RE: Turkey Point Nuclear Plant, Units 3 and 4
Docket Nos. 50-250 and 50-251
Renewed Facility Operating Licenses DPR-31 and DPR-41

Response to Request for Additional Information Regarding License Amendment Request 235, Technical Specifications Changes to Address Non-Conservative Actions for Containment and Control Room Ventilation Isolation Functions

FPL Response to NRC Request for Additional Information (RAI) Regarding LAR 235,
Technical Specifications Changes to Address Non-Conservative Actions for
Containment and Control Room Ventilation Isolation Functions

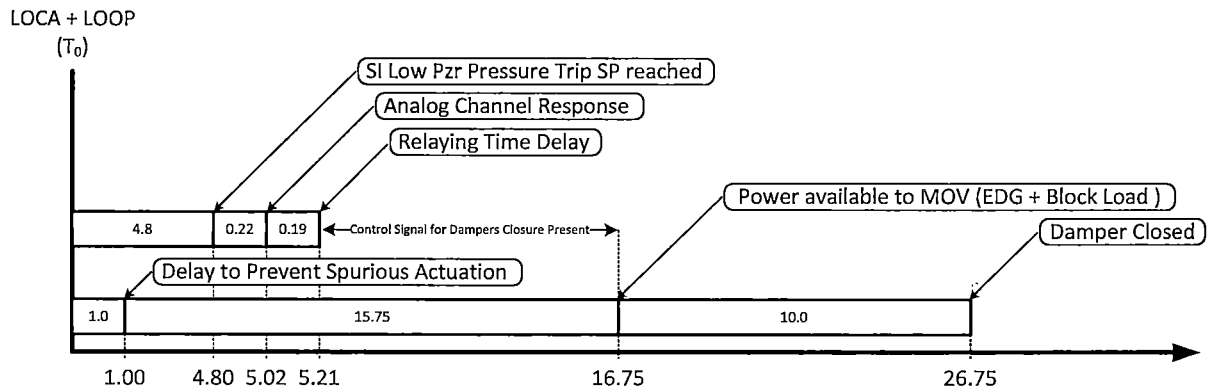
ARCB-RAI-1 (LOCA)

The proposed change deletes functional unit 9.c, "Containment Radioactivity - High," from TS Tables 3.3-2, 3.3-3 and 4.3-2. The NRC staff's review of radiological consequences for the design basis accidents in the Updated Final Safety Analysis Report (UFSAR) determined the loss of coolant accident (LOCA), fuel handling accident (FHA) and rod cluster control assembly (RCCA) ejection accident credit functional unit 9.c to isolate the normal mode of control room emergency ventilation system (CREVS) and establish the recirculation mode. In regards to the LOCA analysis, the licensee determined that the radiological consequence analysis did not need to be reanalyzed because the safety injection signal will provide a containment ventilation and control room isolation signal within the same time as that assumed in the current analysis of record as reflected in Turkey Point's UFSAR; therefore, there is no impact on the LOCA radiological consequences. However, it is not clear to the NRC staff why the timing is the same given the instrumentation differences. Therefore, explain why the timing for the control room isolation signal remains 30 seconds which accounts for the time to reach the signal, the diesel generator start time, load sequencing and damper actuation and positioning time, given the differences between the safety injection instrumentation and the containment radioactivity instrumentation.

For the case of a LOCA concurrent with a Loss of Offsite Power (LOOP), a maximum allowable of 15.75 seconds is credited for loading the Emergency Diesel Generator (EDG) and sequence load block 1, which powers the CREVS motor operated valves (MOV), supply fan, air handlers and

condenser. The EDG and sequencer would load in parallel to the SI protection relays. Since the SI signal is battery backed, the associated relays actuate in 5.21 seconds; i.e. the same as it would with offsite power available. In this scenario, an SI signal would place the CREVS in service within 26.75 seconds (16.75 seconds for motive power + 10 seconds for CREVS recirculation mode). The graphic below illustrates this scenario's timing.

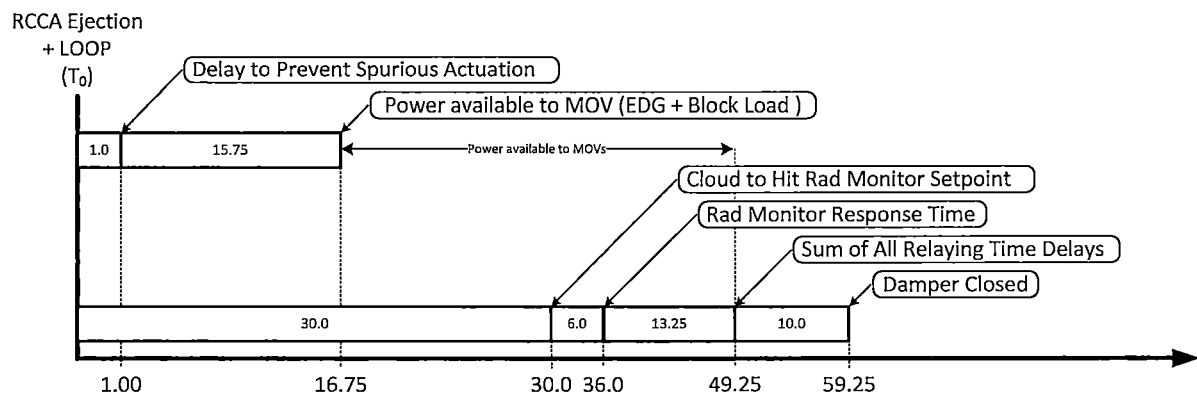
ARCB-RAI-2 (RCCA ejection)

It is not clear to the NRC staff which time is correct and why the timing is the same given the instrumentation differences. Therefore, explain which delay time is correct and then explain why the timing for the control room isolation signal remains 60 seconds which accounts for the time to reach the setpoint (30 seconds), signal processing, and damper closure time, given the differences between the control room normal intake instrumentation and the containment radioactivity instrumentation.

The table below demonstrates that radiation from a RCCA ejection would isolate the control room and actuate the CREVS within 60 seconds by means of the control room normal intake radiation monitors.

If offsite power is lost coincident with a RCCA ejection, motive power would be available from the EDG within a maximum allowable 16.75 seconds. Hence, emergency power would be present prior to the 30 seconds assumed for the radioactive cloud to actuate the control room radiation monitors. Therefore, a RCCA ejection with or without offsite power would not change the CREVS recirculation mode initiation time. The graphic below illustrates this scenario's timing.
